SUBJECT: Comment Response Letter – Meridian Road (CDR-19-004)

Please see the following responses in ***bold and italics*** for the 2nd review of Bent Grass Residential Filing No. 2.

C0.0

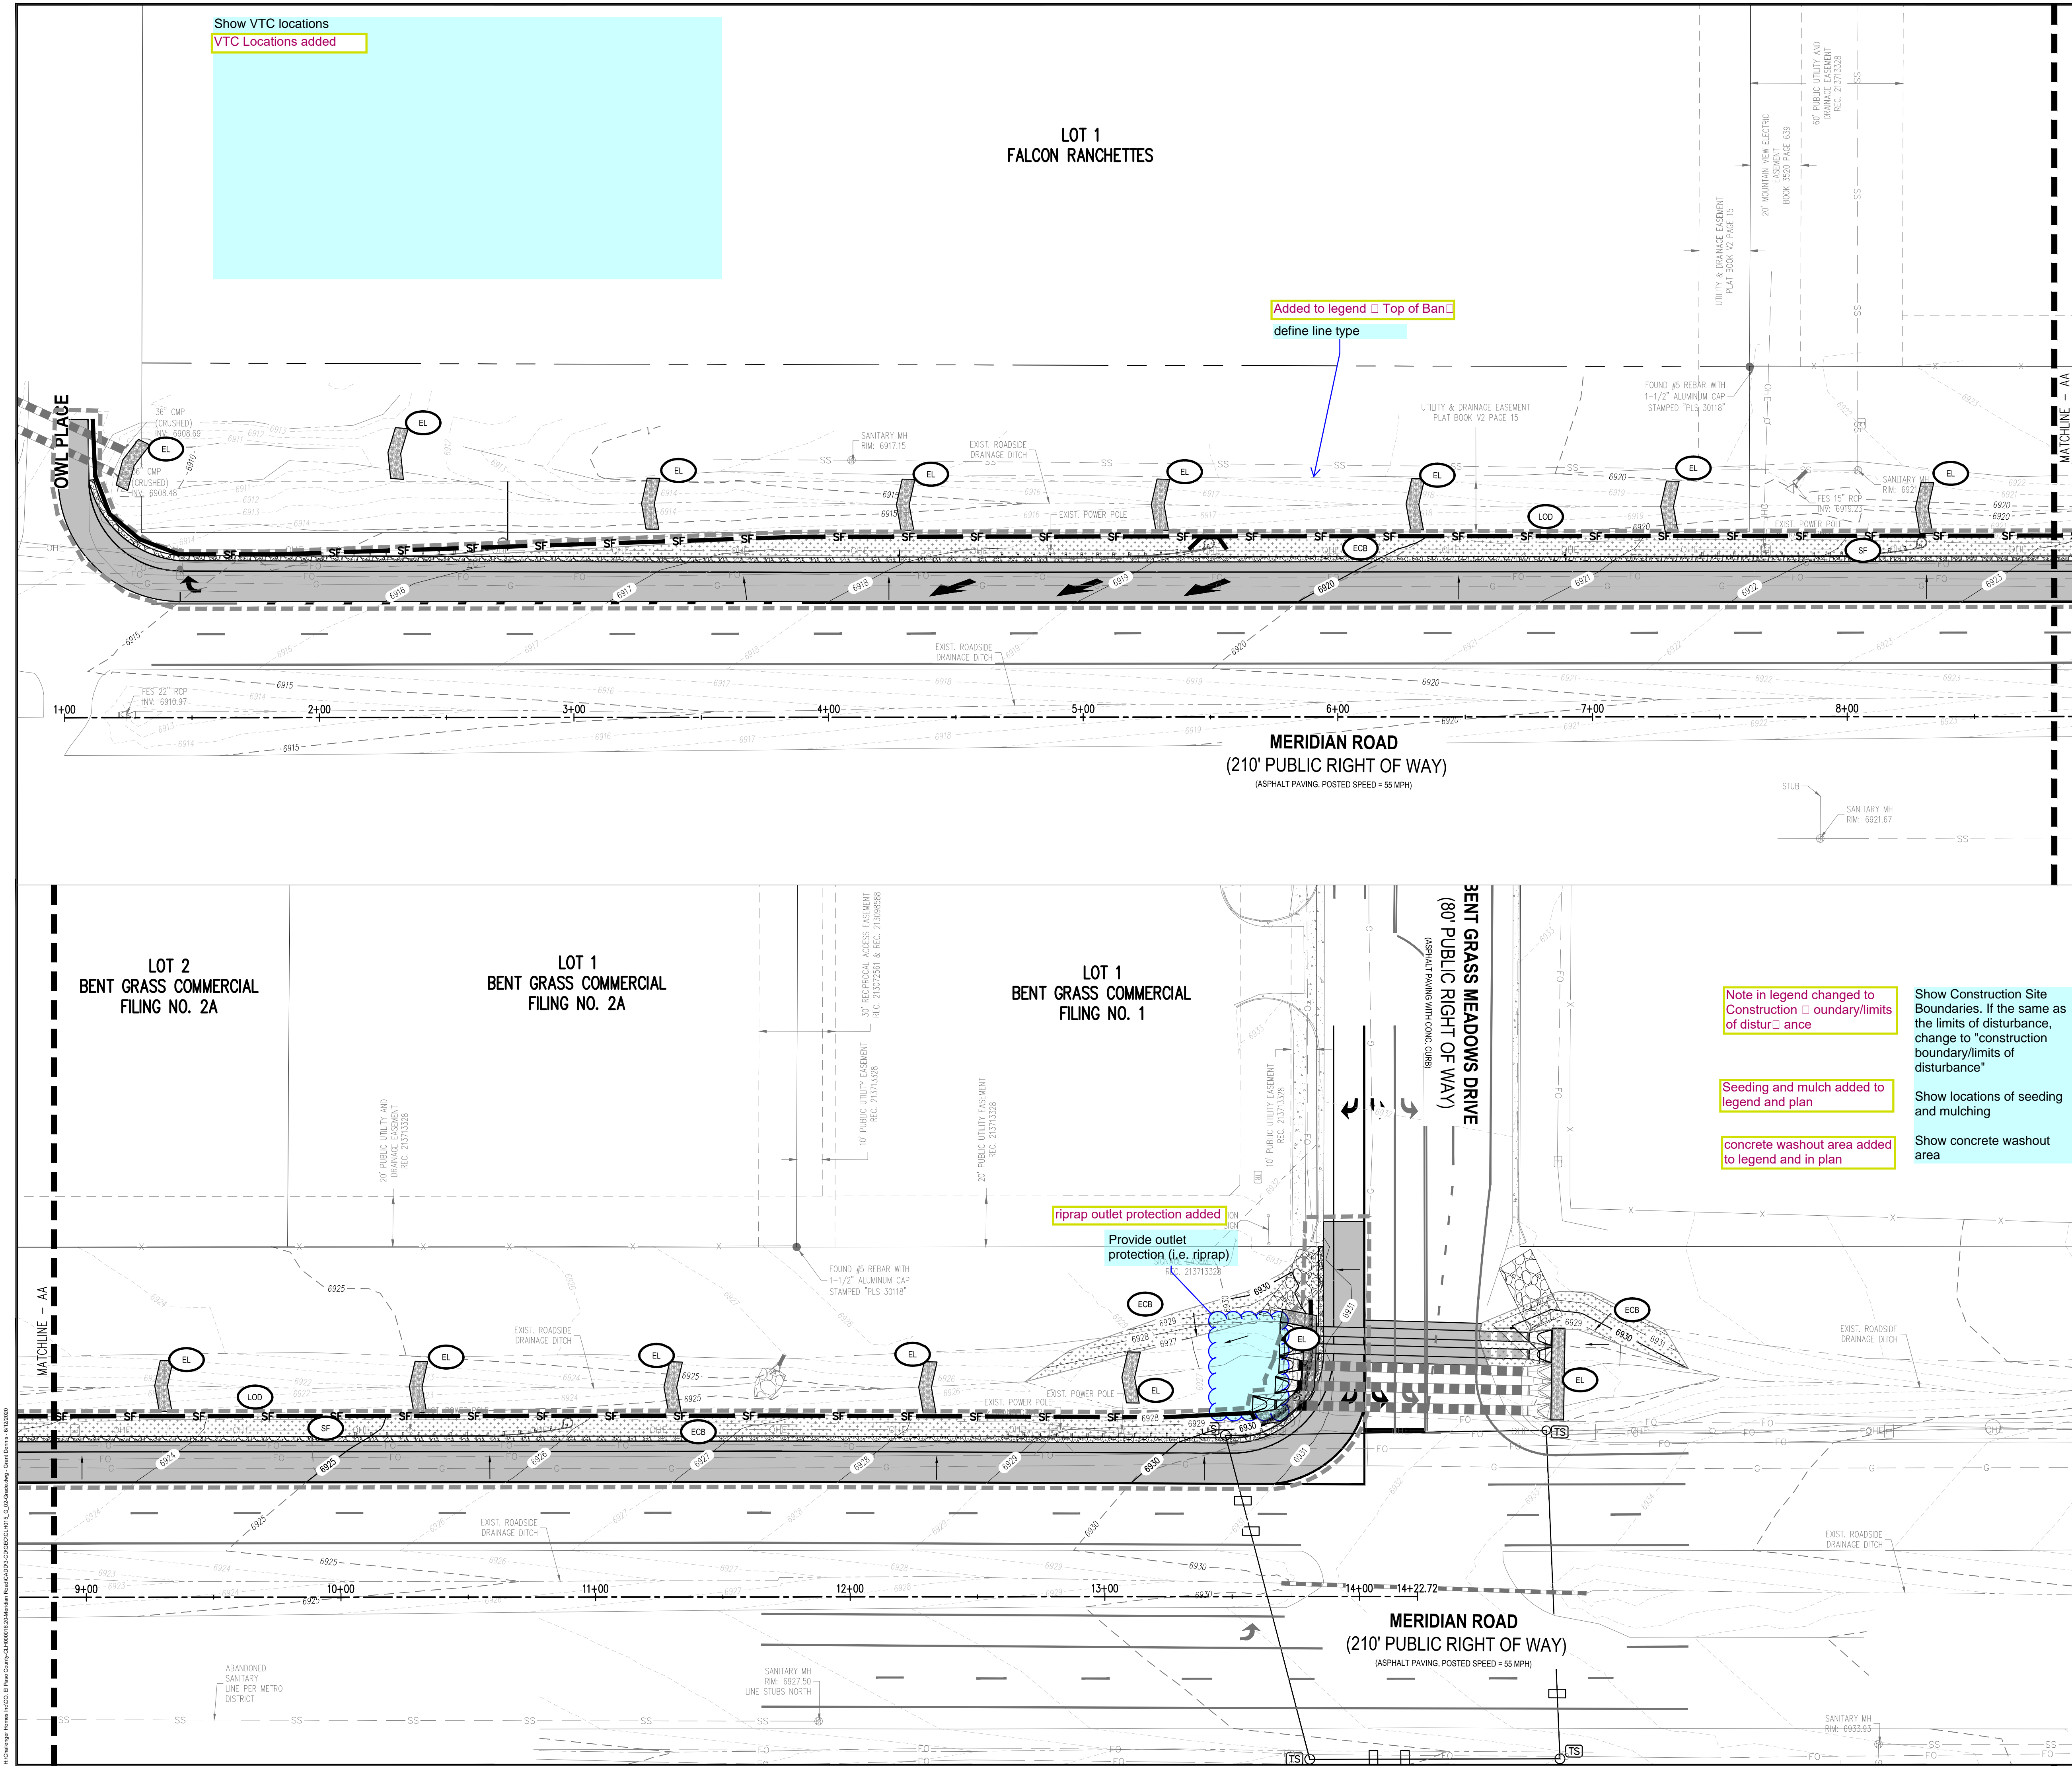
Show VTC locations
VTC Locations added

Show Construction Site Boundaries. If the same as the limits of disturbance, change to "construction boundary/limits of disturbance"

Seeding and mulch added to legend and plan

concrete washout area added to legend and in plan
